September 26, 2016

Docket ID No. EPA-HQ-OAR-0827

Docket ID No. NHTSA-2016-0068

Alliance of Automobile Manufacturers Comments on Draft Technical Assessment Report: Midterm Evaluation of Light-Duty Greenhouse Gas Emission Standards and Corporate Average Fuel Economy Standards for Model Years 2022-2025 (EPA-420-D-16-900, July 2016)

Figure A-1: Comparison of NHTSA Base Engine Map to similar OEM 2.0L Benchmark Engine

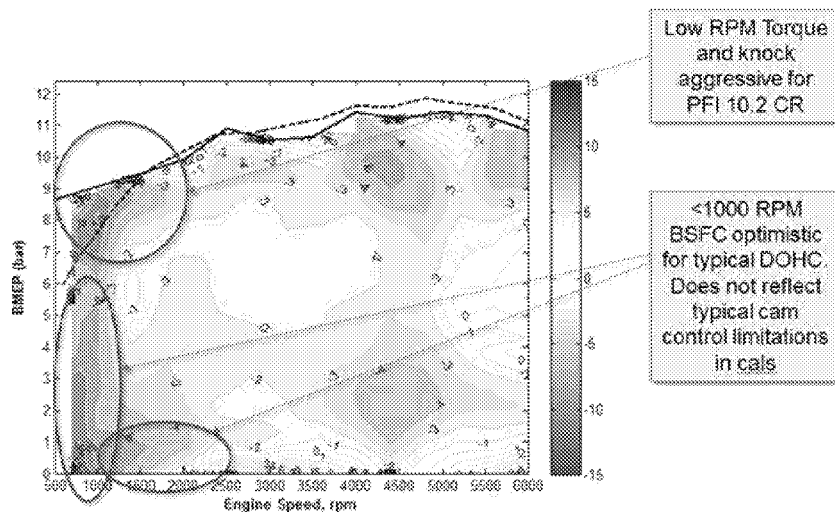
Figures A-1 and A-2 below capture the BSFC delta comparison with the key findings. Figure A-1 is a comparison to an original equipment manufacturer (OEM) benchmark 2.0L, four cylinder (cyl), naturally aspirated (NA), PFI, DOHC, dual cam variable valve timing (VVT), 10.2 CR engine. Figure A-2 is a comparison to a Honda Accord 2.4L, 4cyl, NA, gasoline direct injected (GDI), DOHC, VVT, 2-step VVL, 11.1 CR engine benchmarked by the United States Council for Automotive Research (USCAR). These comparisons illustrate the optimistic assumptions in the NHTSA Base Engine Map, as the efficiency of the NHTSA Base Engine Map is similar to a production engine with much more technology.

Figure A-3: Comparison of IAV Gasoline Engine2 Map to NHTSA Base Engine Map

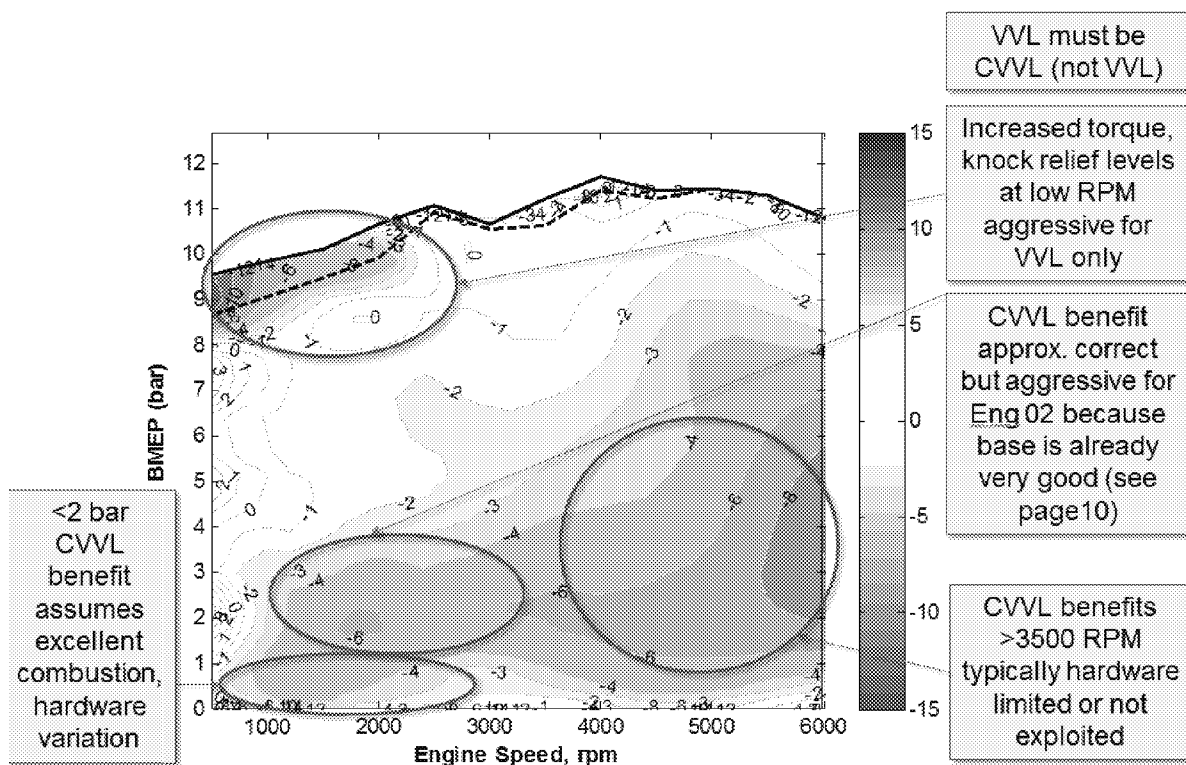
Figure A-3 compares the BSFC of the NHTSA Base Engine Map to the IAV Gasoline Engine2 Map with the key findings highlighted.

Figure A-4: Comparison of IAV Engine3 Map to IAV Engine2 Map

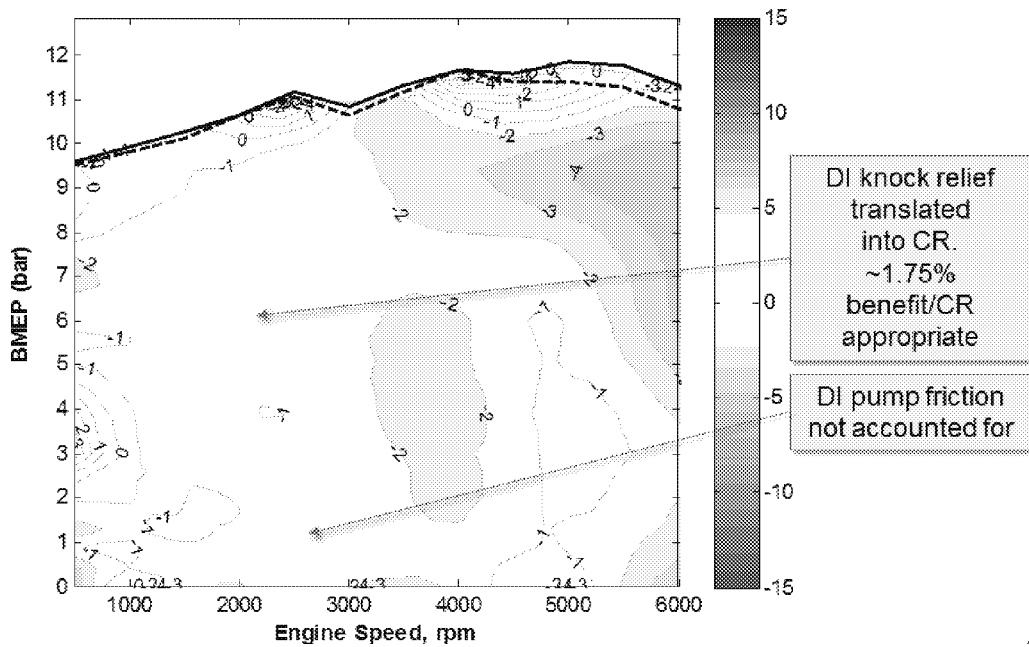
- The GDI pump friction isn't properly taken into account (Figure 1-4).
- Optimistic knock relief assumptions are used (Figure 1-4).
- Aggressive CVVL assumptions for low load operation were made across the speed band (Figure 1-5).
- The pumping work reduction is overstated, especially considering that the benchmark Honda engine used for comparison here is already a 2-Step VVL engine (Figure 1-5).

Figures A-4 and a-5 below capture the BSFC comparison with the key findings. Figure A-4 is a comparison to IAV Engine2 Map to isolate estimated GDI benefits. Figure A-5 is a comparison to the USCAR benchmarked Honda 2.4L engine with similar technologies.

Figure A-6: Comparison of IAV Engine4 Map to IAV Engine3 Map

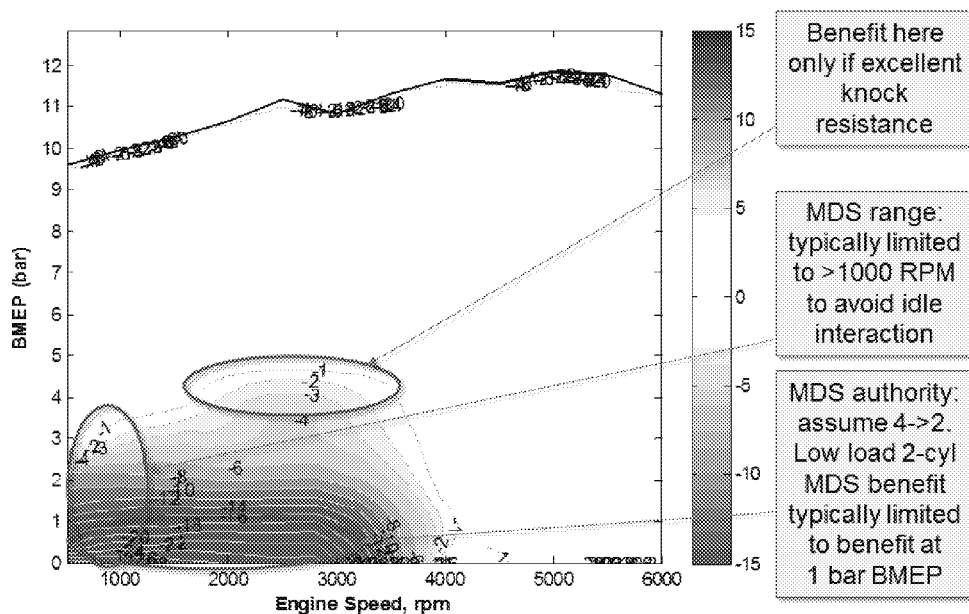
Figure A-6 below captures the BSFC comparison with the key findings.

Figures A-7, A-8, A-9, and A-10 below capture the BSFC comparisons to with the key findings:

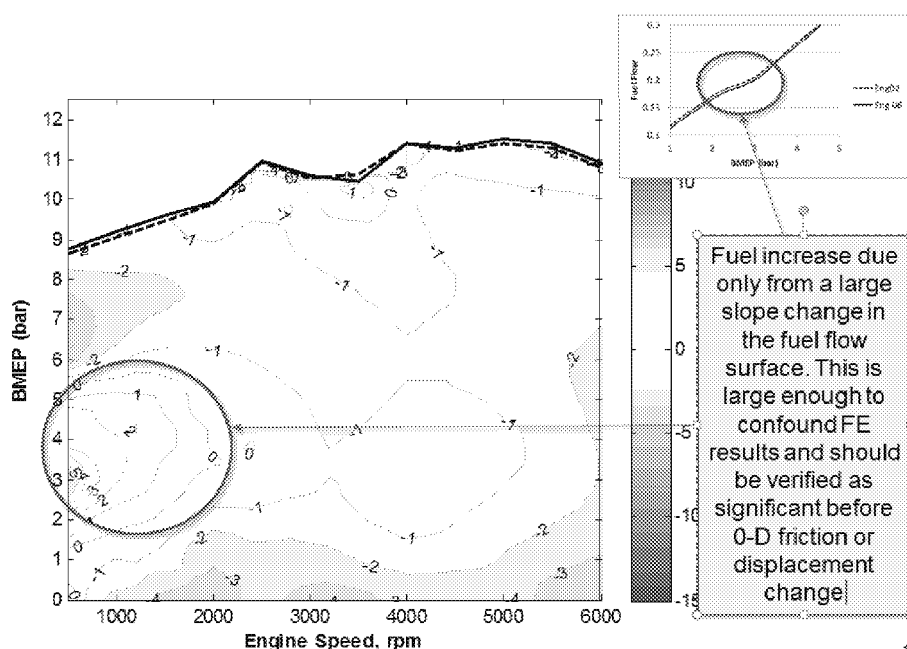
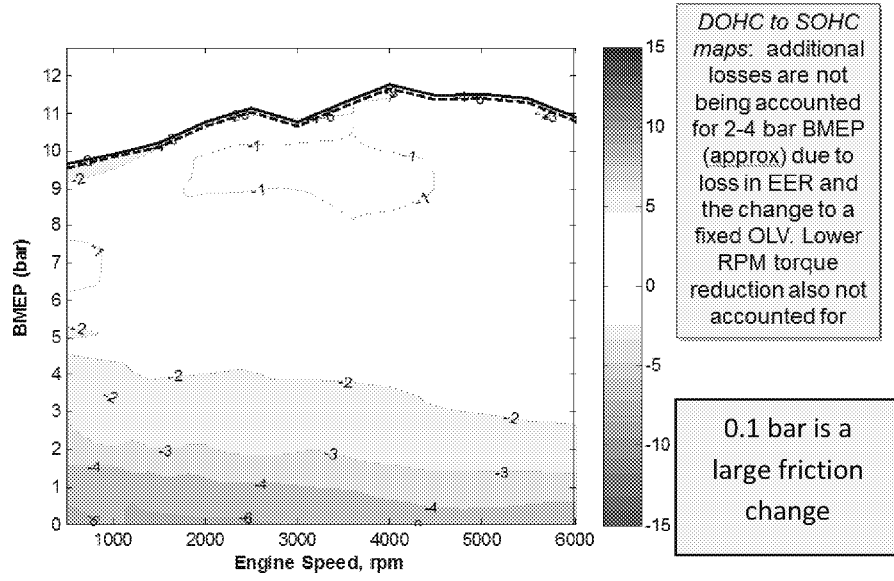
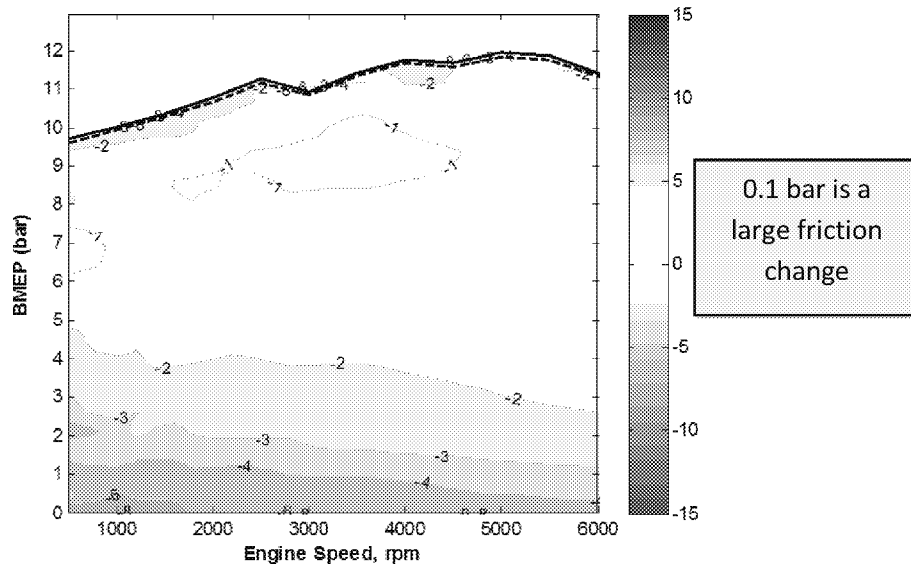
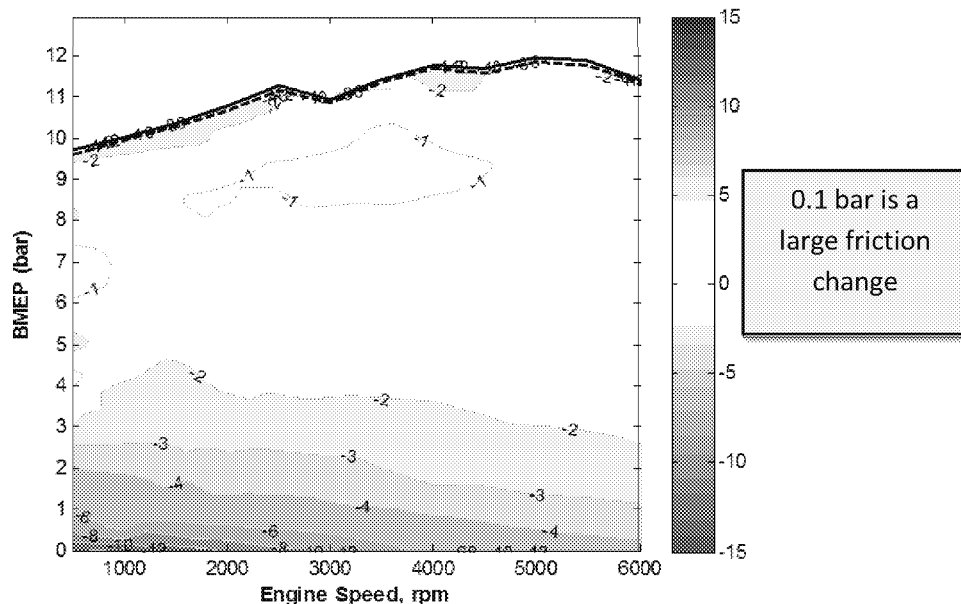
- All four engine maps assume a large friction reduction (0.1 bar) across the board.
- Additional losses, due to loss in Effective Expansion Ratio (EER) and the change to a fixed overlap volume (OLV), are not taken into account.
- Lower RPM torque reduction does not appear to be accounted for accurately.
- The benefit in the 2-4 bar region appears to be overstated given that the cams cannot move relative to each other in SOHC engines.

Figure A-11: IAV Gasoline Engine12 Map - Atypical Fuel Surface for Downsized Turbocharged Engines Running on 93 RON Fuel

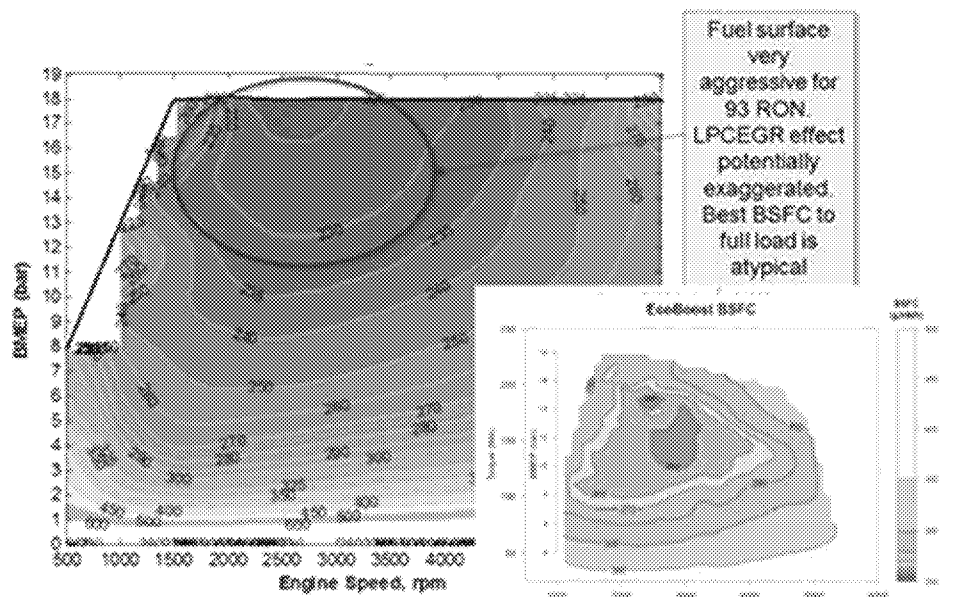
- The engine maps for boosted engines show best BSFC all the way to full load; this is not typical.
- For boosted engines with CEGR, the low-pressure CEGR (LPCEGR) effect appears exaggerated.

Figure A-13: Comparison between IAV Gasoline Engine12 Map and IAV Gasoline Engine13 Map; Displacement Change without Full Modeling Questionable

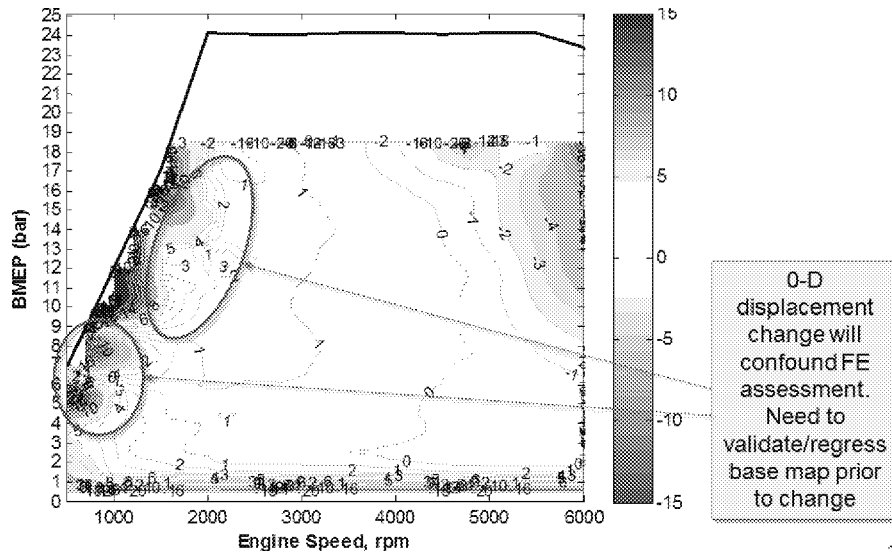
Figure A-13 captures the effect of a 0-D displacement change from 1.6L to 1.2L (downsizing effect).

Figure A-14: IAV Gasoline Engine14 Map - Aggressive Fuel Surface With Atypical Results

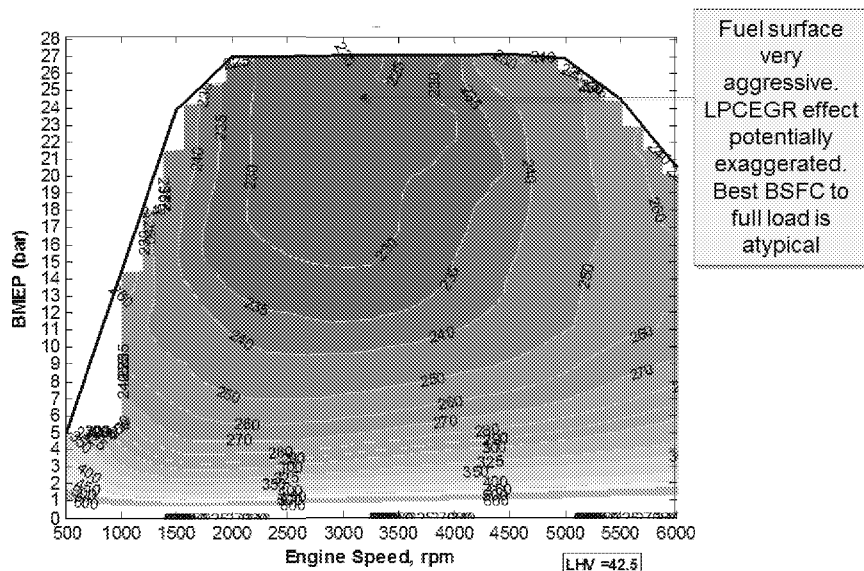
Figure A-14 below illustrates the effect of aggressive LPCEGR on the 1.0L 3-cylinder engine.

Figure A-15: Lumped Parameter Model compared to Test Data

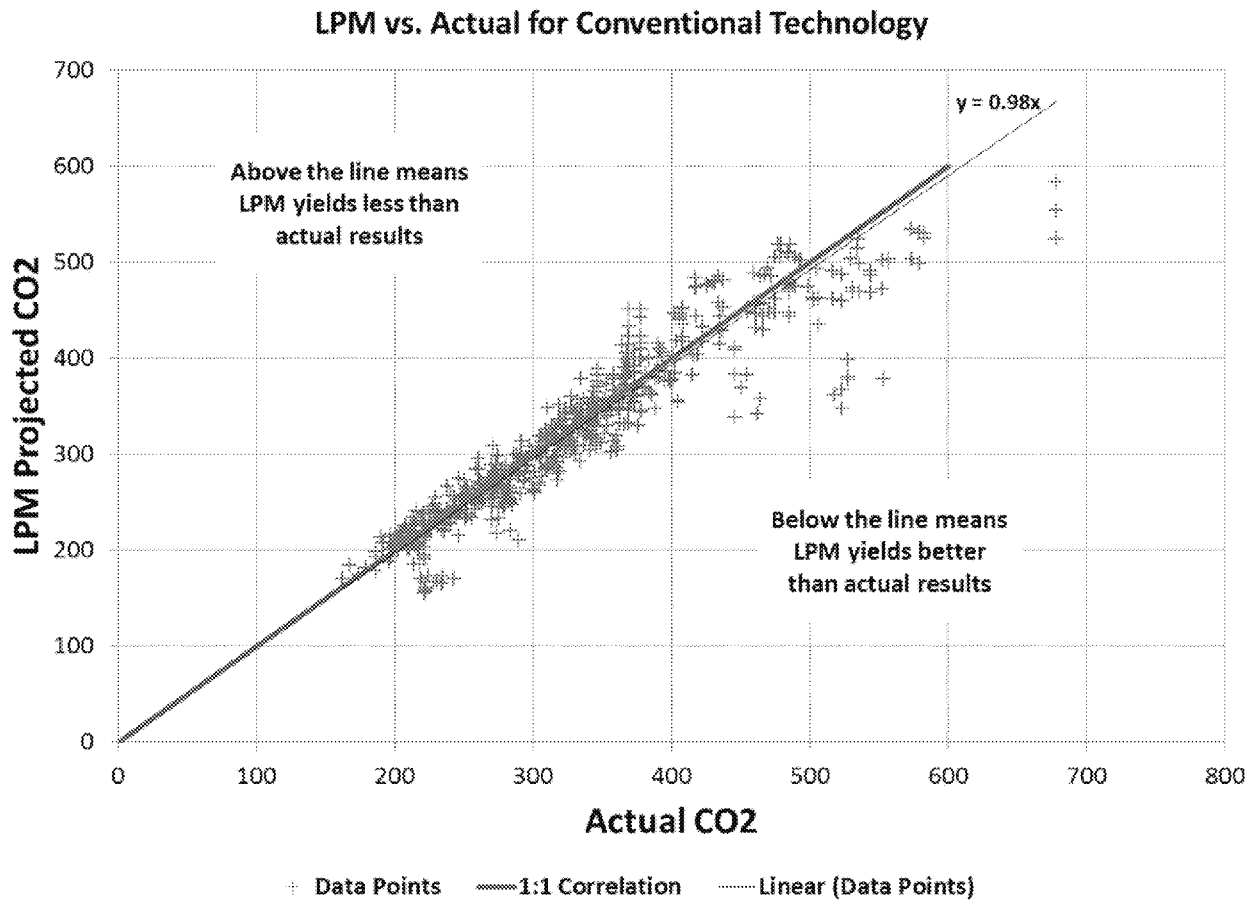
The results of this process, after sorting for conventional technologies (no hybrids, turbocharged engines, or eight-speed transmissions), are plotted below in Figure A-15. In this and the following figures, results below the line show data where the LPM predicted lower CO₂ than the vehicle actually emitted. Conversely, points above the line show when the vehicle was better than the LPM estimate. The standard error for this data is 31 g/mi, but the overall slope calculated as a best-fit line is about 2% from actual.

Figure A-16: Lumped Parameter Model compared to Test Data of Vehicles with 8-Speed Transmissions

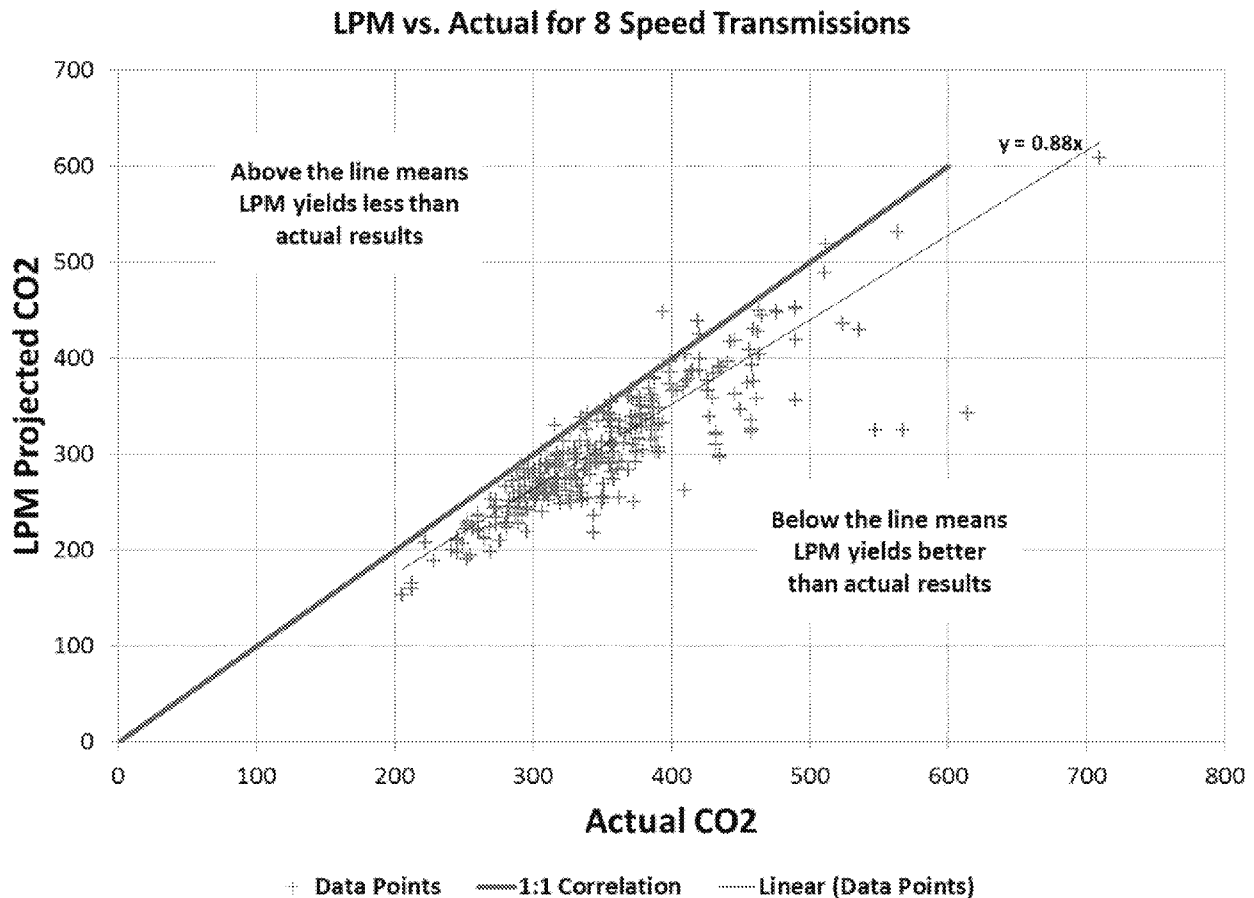
Figure A-16 shows the data after filtering for only eight-speed transmissions. Here the standard error has increased to 49 g/mi, but of greater concern is the change in slope of the best-fit line. The overall trend shows that the LPM is more optimistic by 12% than what manufacturers have, on average, been able to deliver. This is the powertrain technology, aside from variable valve timing, with the highest projected penetration (~90%) from the OMEGA model.⁷⁵

Figure B-1: Comparison of Mazda SkyActiv 2.0 L - EPA Data (96+ RON) vs. USCAR Data (91 RON)

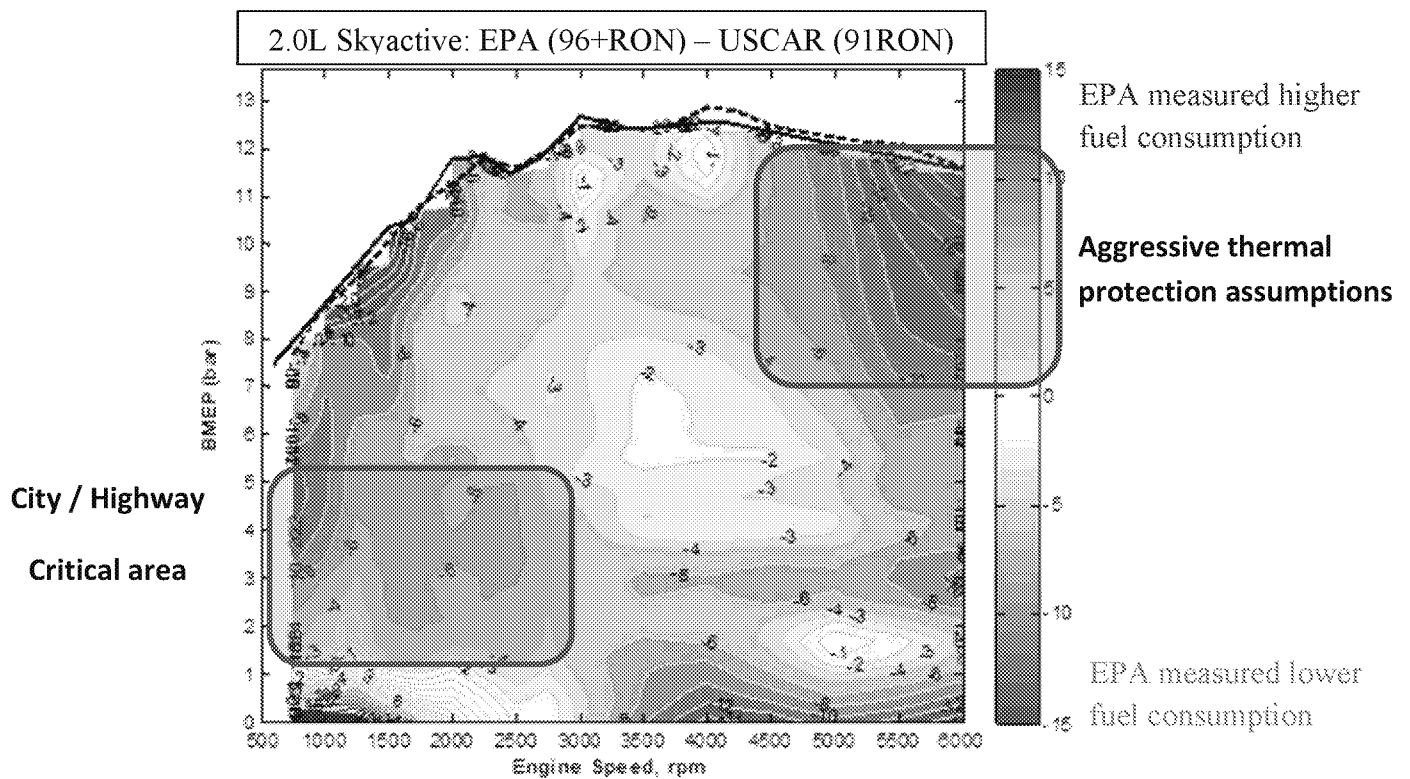
The differences between the USCAR and EPA fuel maps described in the paragraph above are shown in Figure B-1 below. The green areas in the plot (where EPA projects lower fuel consumption than USCAR) are due to knock limit improvements associated with EPA's use of premium fuel for benchmarking. The octane advantage can clearly be seen in the comparison, and results in engine fuel map benefits that cannot be achieved with market grade regular and Tier 3 certification test fuels.
